Addendum 01

DOCUMENT 00 91 00

PROJECT: Tipp City Seniors New Addition
528 North Hyatt Street
Tipp City, Ohio 45371

PROJECT #: **25059.00**

FIRST FLOOR PLAN - UNIT A

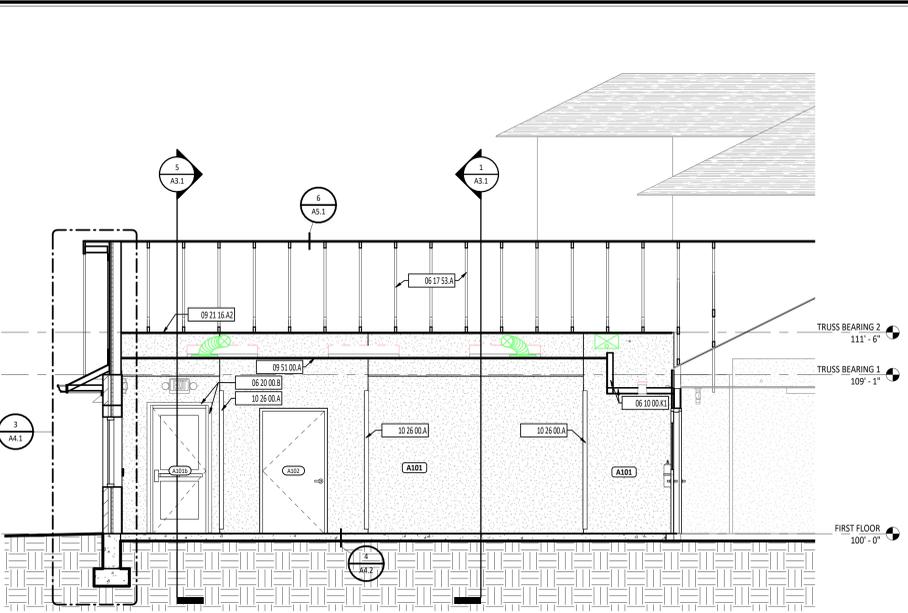
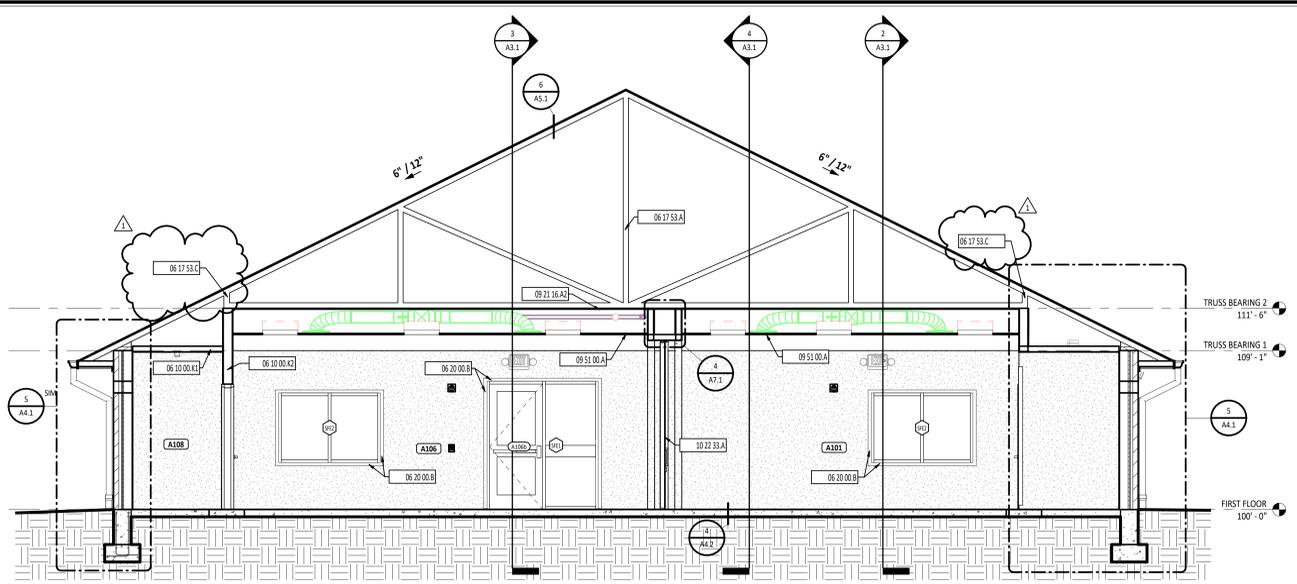
2. Drawing Sheet A1.1 First Floor Plan – Unit A:
 - a. Revised dimension for new double door to include 'verify in field'.
3. Drawing Sheet A3.1 Building Sections:

SHEET TITLE:
BUILDING SECTIONS

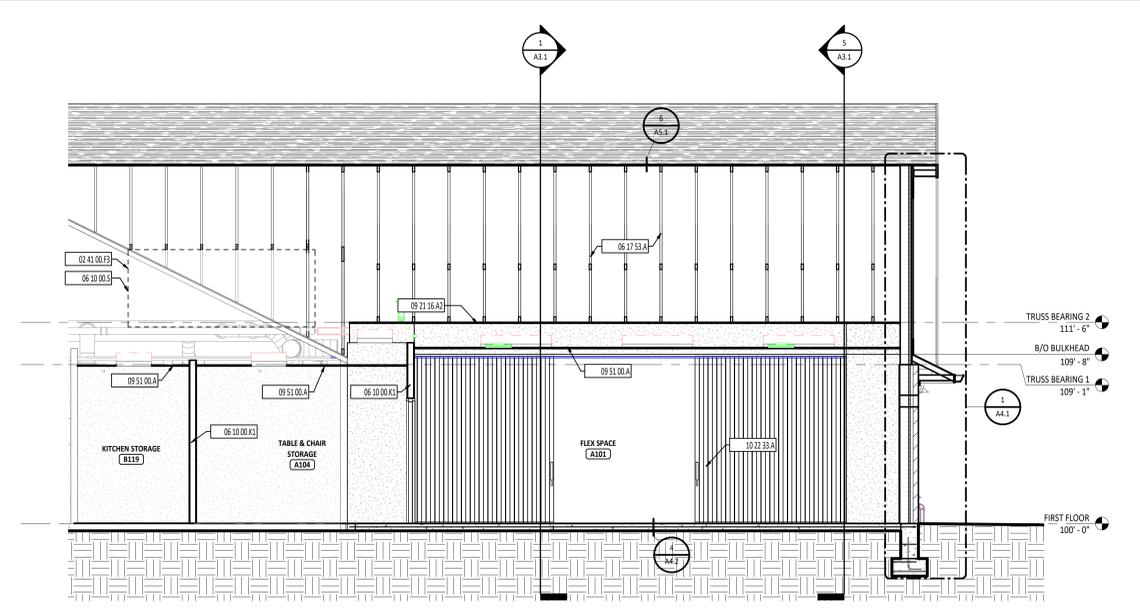
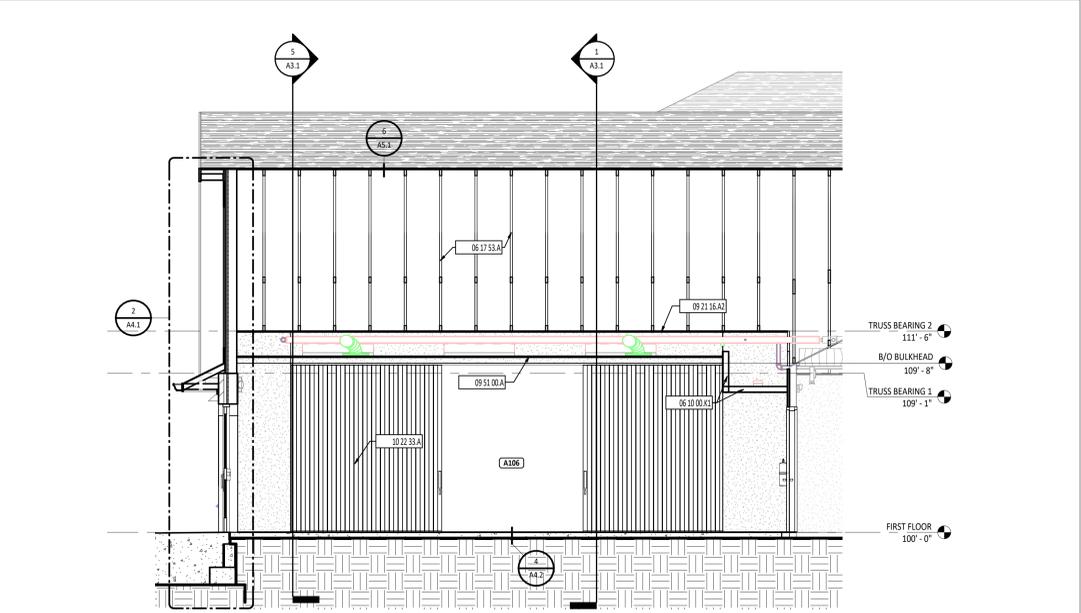
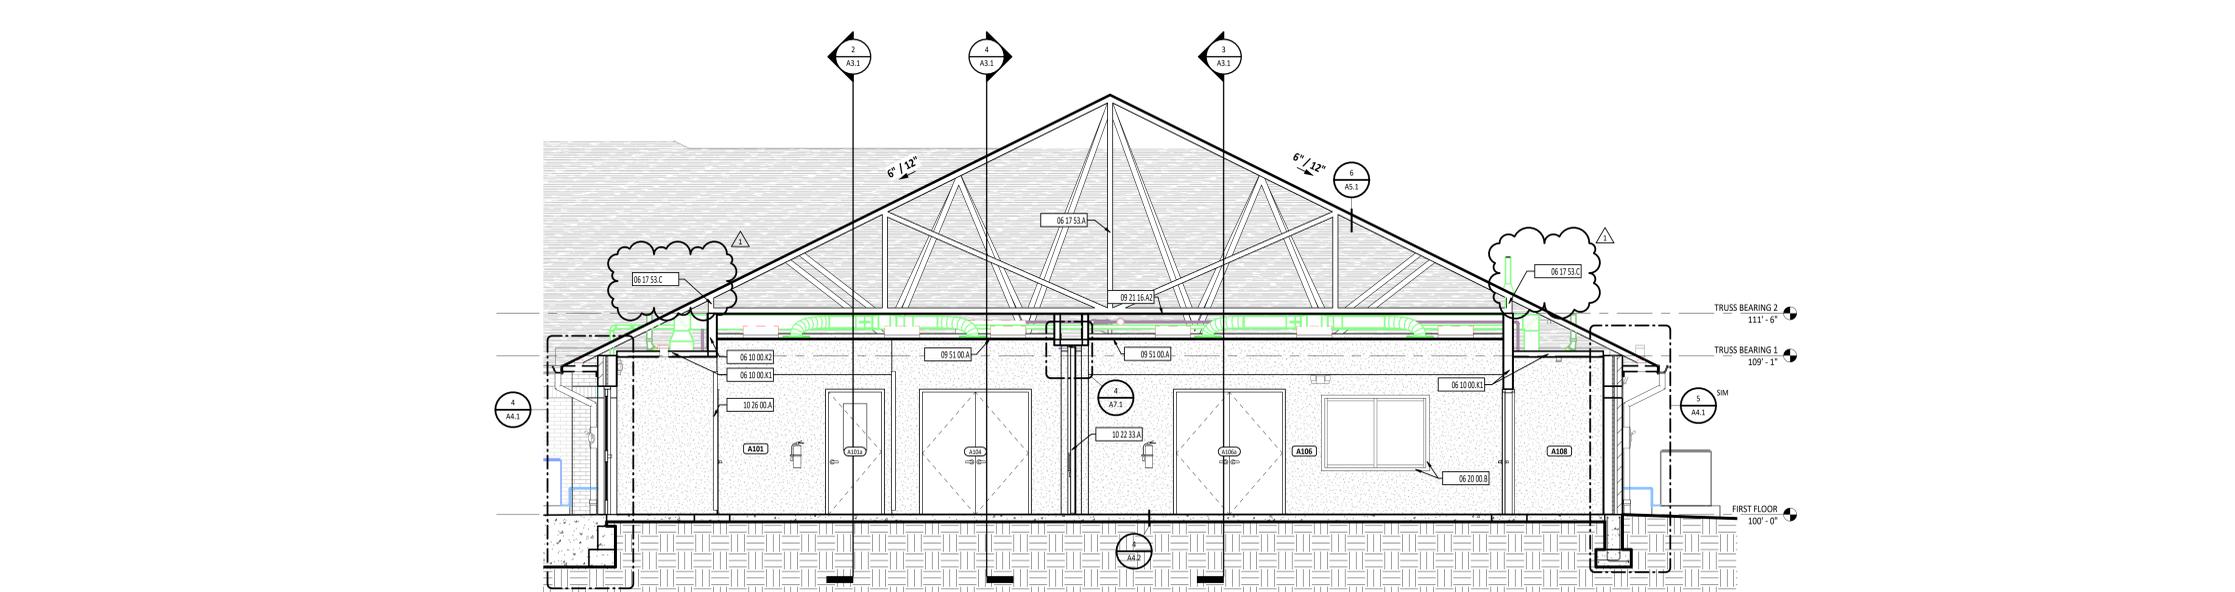
- a. Added keynotes on sections 1/A3.1 and 5/A3.1 for the truss heel.
4. Drawing Sheet A7.1 First Floor Reflected Ceiling Plan – Unit A:
 - a. Added locations and keynotes for fireblocking.

ROOF FRAMING PLAN

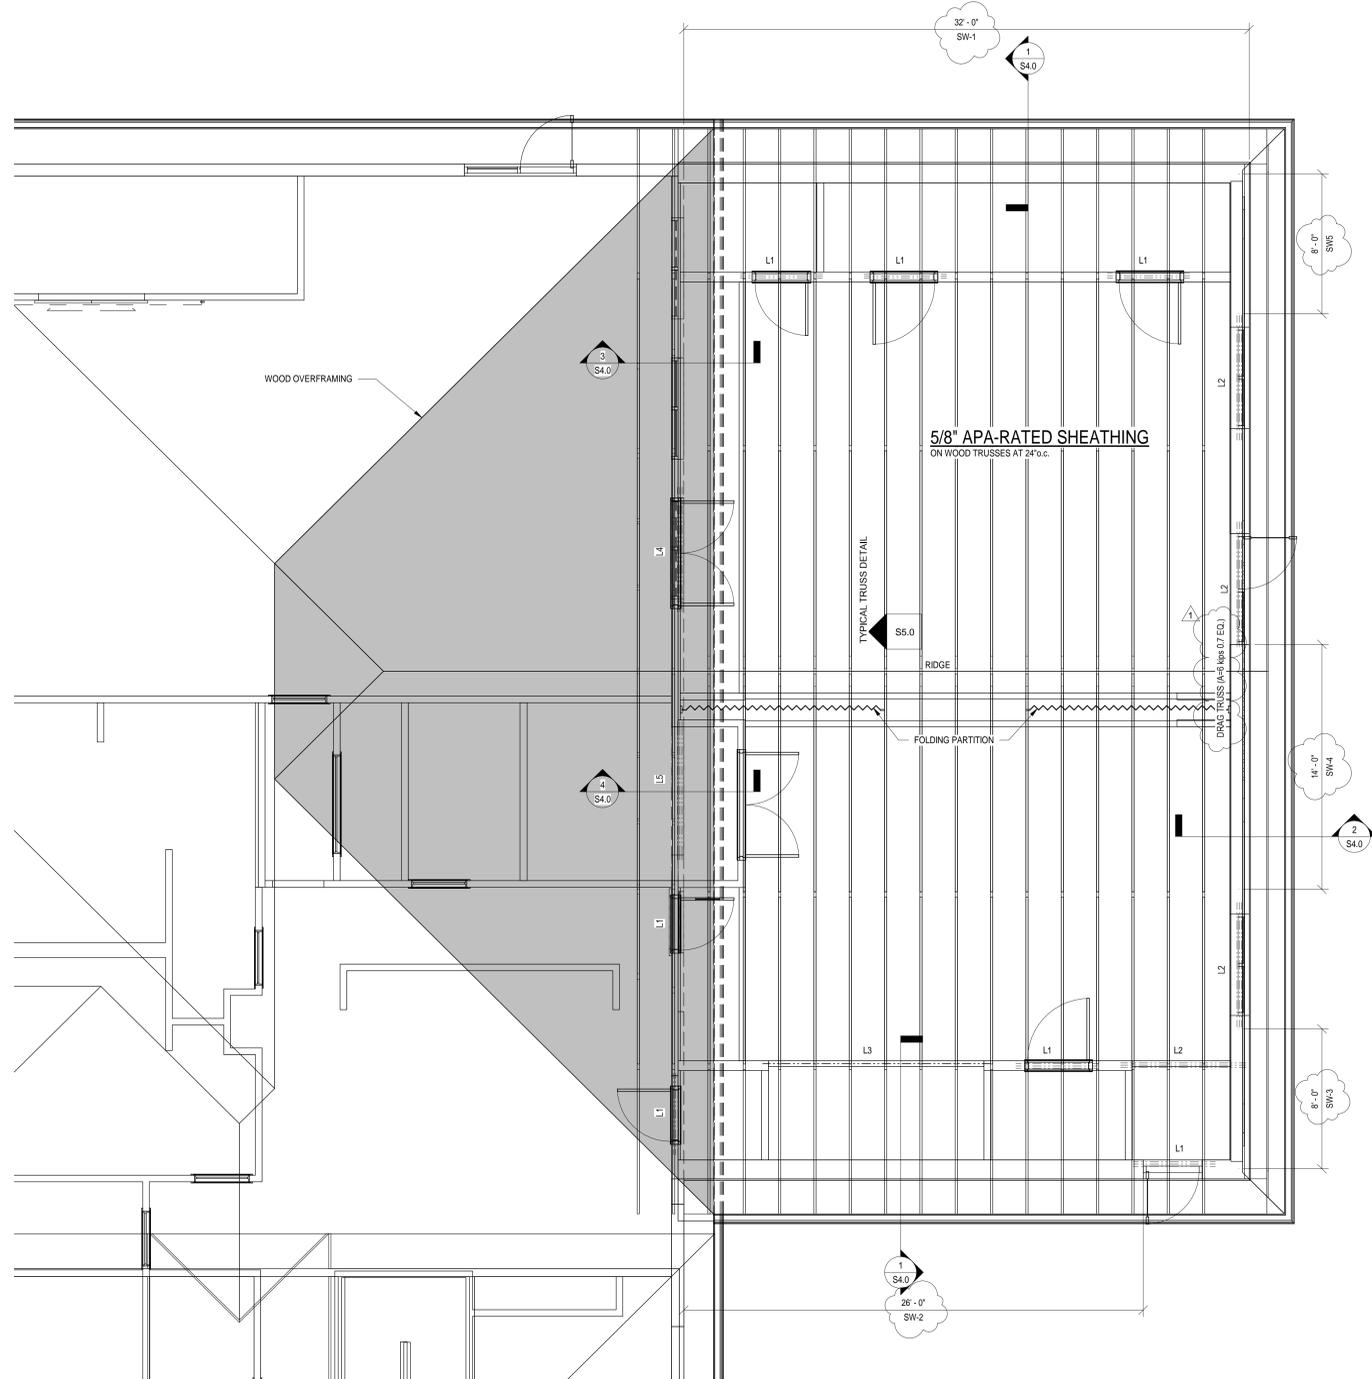
5. Sheet S0.1 Structural Notes: Revised Design Criteria Notes
6. Sheet S1.0 Foundation Plan: Added Shear Walls and dimensions
7. Sheet S3.0 Roof Framing Plan: Added Shear Walls and dimensions

5
S4.0
3/4" = 1'-0"

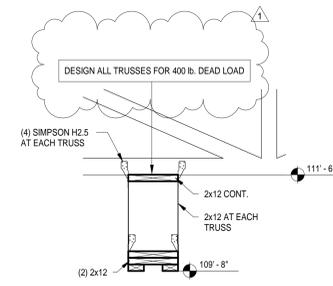
- c. Section 5/S4.0: Added truss design load from folding partition
9. Sheet S5.0 Wood Truss Bracing: Added gable end wall bracing detail
10. Sheet S5.1 Wood Shearwall: Added entire sheet of wood shear wall details

2
S4.0
3/4" = 1'-0"

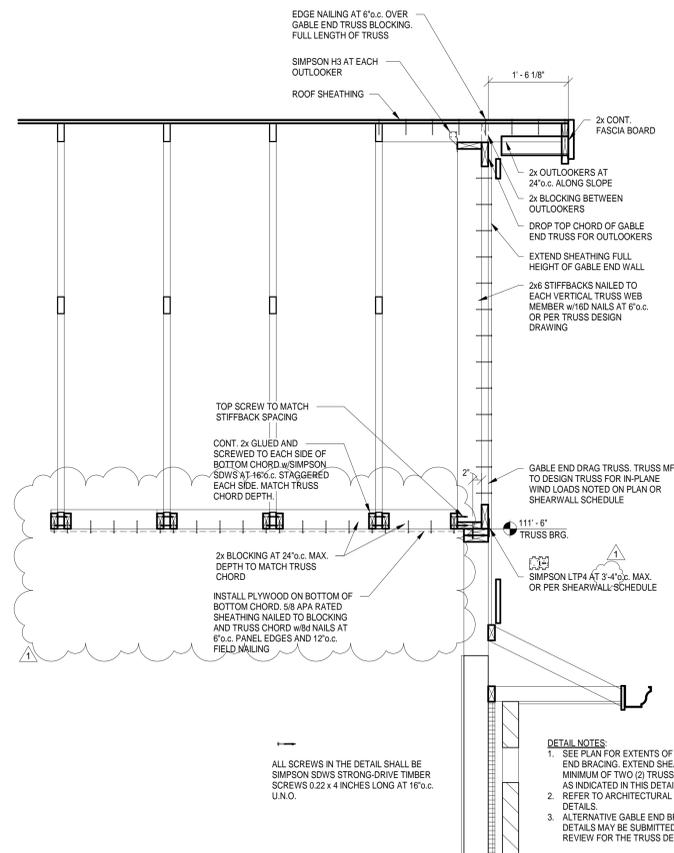
8. Sheet S4.0 Framing Sections:
 - a. Section 1/S4.0: Added blocking note and revised soffit elevation
 - b. Section 2/S4.0: Revised bottom chord sheathing
